PLANNING REPORT

Architectural Review Board

Wednesday, January 29, 2025

48 S. High Street Façade Improvements 25-004INF

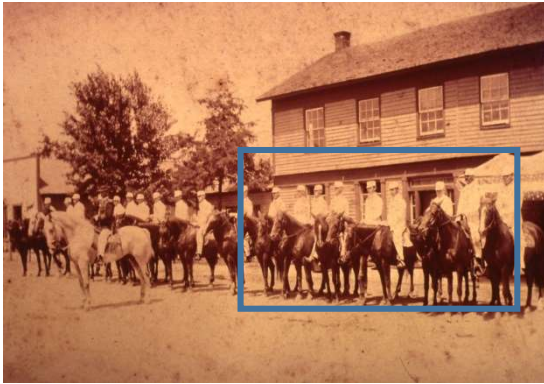
The applicant initially aimed to align the façade restoration with the neighboring building at 50-52 S. High Street, which has also been altered on several occasions. Staff has advised the applicant to avoid using any faux historical elements and to base the restorations on evidence found in historical images. Below are the proposed improvements for the front façade, indicated within a blue rectangle.

The applicant proposes using a Therma-Tru fiberglass front door and a Pella lifestyle 51-inch x 55-inch window. The proposed door would require a Waiver. The Board has approved a fiberglass door Waiver for both Landmark and Background buildings where the Waiver criteria are met. Per *Historic Design Guidelines* Section 4.16 (A), design should be consistent with the historic storefront character, including window sizes and architectural features. Per Section 4.8 (C & D) of the Guidelines, any downsizing or enlarging of window openings shall be avoided and windows should match the appearance of the historic originals. The applicant proposes to use the exact same awning detail over the door and window currently attached to the cornice on the southern portion of the building in black color. It's relevant to note that the improvements for 50 S. High would not be supported under the current Code and Guidelines because the original fenestration was changed so dramatically.

The existing landscaping near the bay windows is proposed to be removed and replaced with brick pavers per the Bridge Street streetscape character.

Additionally, staff has encouraged the applicant to collaborate with a preservation architect familiar with the District. This will not only generate a more appropriate design, but also ensure that interior adjustments are appropriate and can meet Building Code. In the long run, this will save the applicant both time and money. To assist in this process, the applicant has been provided with a National Preservation document titled "Rehabilitating Historic Storefronts," which outlines preservation techniques and guidelines for storefront restoration and redesign. Staff is requesting the Board's feedback.
